South Texas Project Electric Generating Station P.O. Box 289 Wadsworth, Texas 77483

August 19, 2010  
U7-C-STP-NRC-100193

South Texas Project  
Units 3 and 4  
Docket Nos. 52-012 and 52-013  
Revised Response to Request for Additional Information

**RAI 03.08.04-18, Revision 1, Supplement 1****QUESTION:****Follow-up to Question 03.08.04-2 (RAI 2964)**

FIGURE 9A.4-31 RADWASTE BUILDING, FIRE PROTECTION, AT ELEVATION 12300 MM

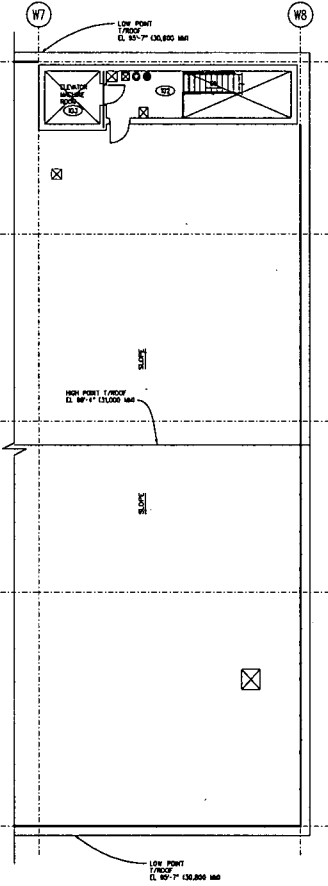
#### **Fire Protection (Figures 9A.4-28 through 9A.4-32)**

The Fire Protection figures for the RWB are revised to reflect some changed locations of hose racks, stand pipes, extinguishers, and fire barriers (walls and floors). None of these items is deleted or added. The relocation is due to the interior reconfiguration of the RWB discussed in Attachment 1. There are no functional changes to the RWB fire protection provisions.

Figure 9.4-10 - Radwaste Building HVAC P&ID (Sheet 1 of 3)

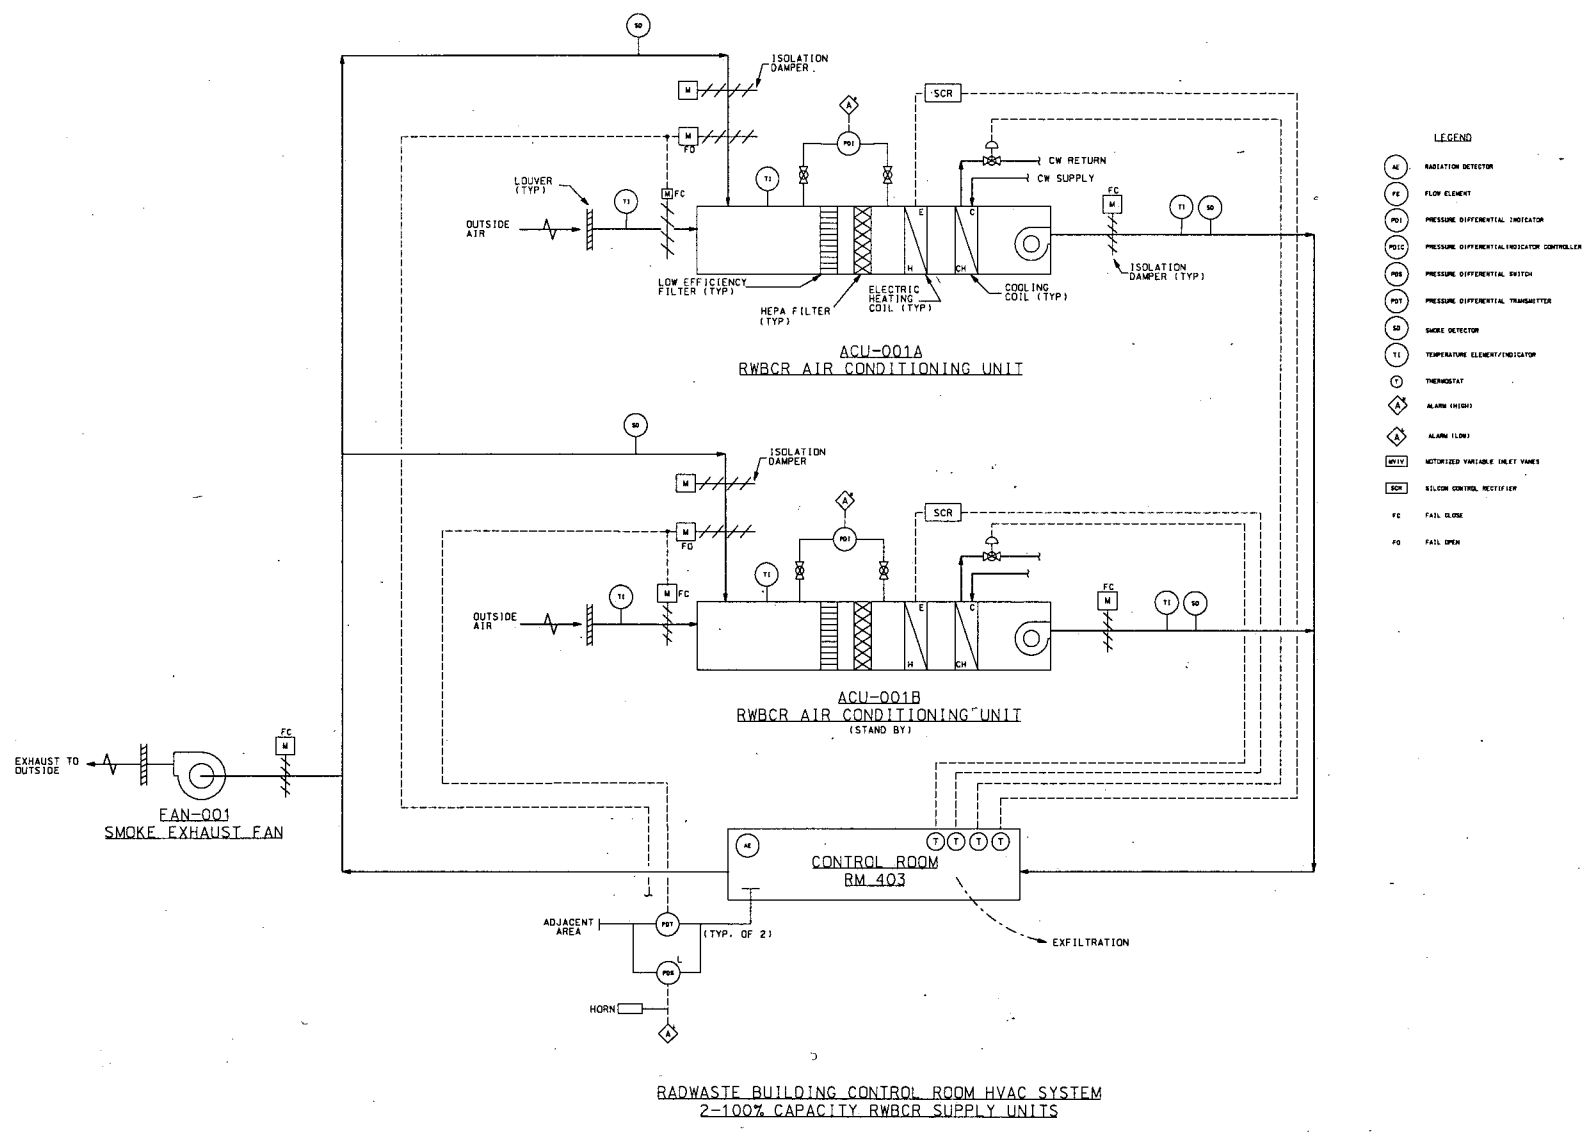
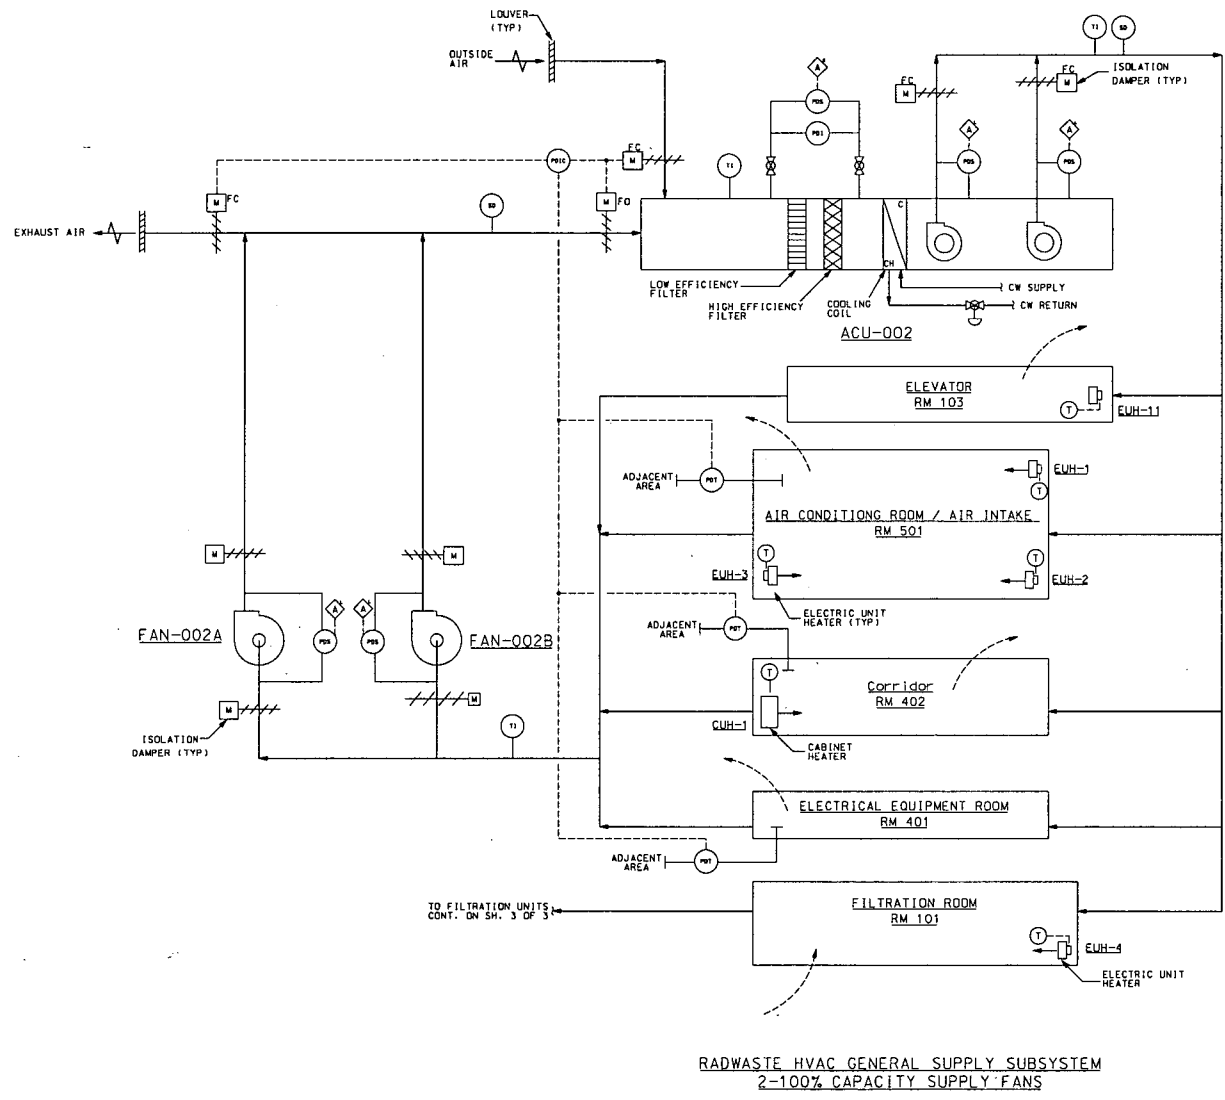
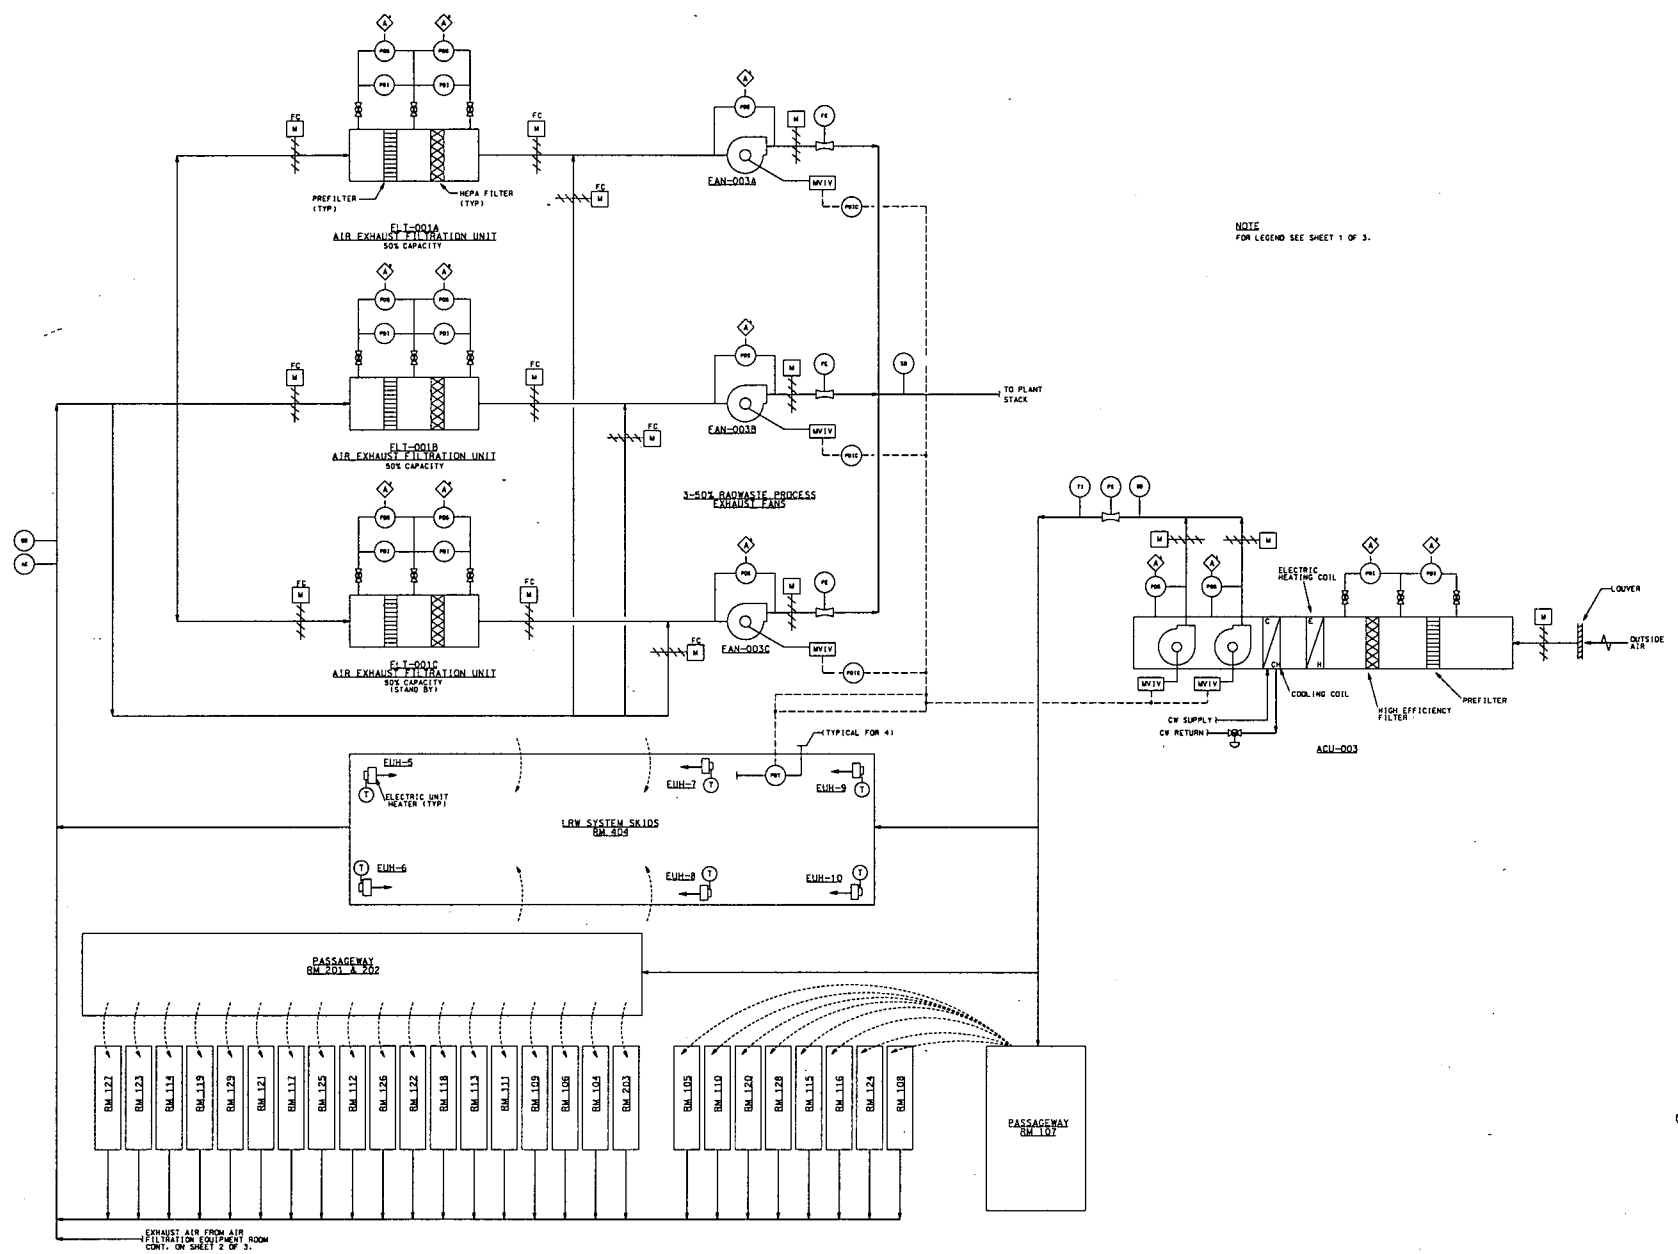
HVAC P&IDs (Figure 9.4-10)

The room numbers and room descriptions for several of the rooms shown on this figure (e.g., Control Room, Electrical Equipment Room, etc.) have been changed to match the room numbers and descriptions shown on the RWB GA figures. These are administrative changes which do not affect the operation or function of the equipment or facility.
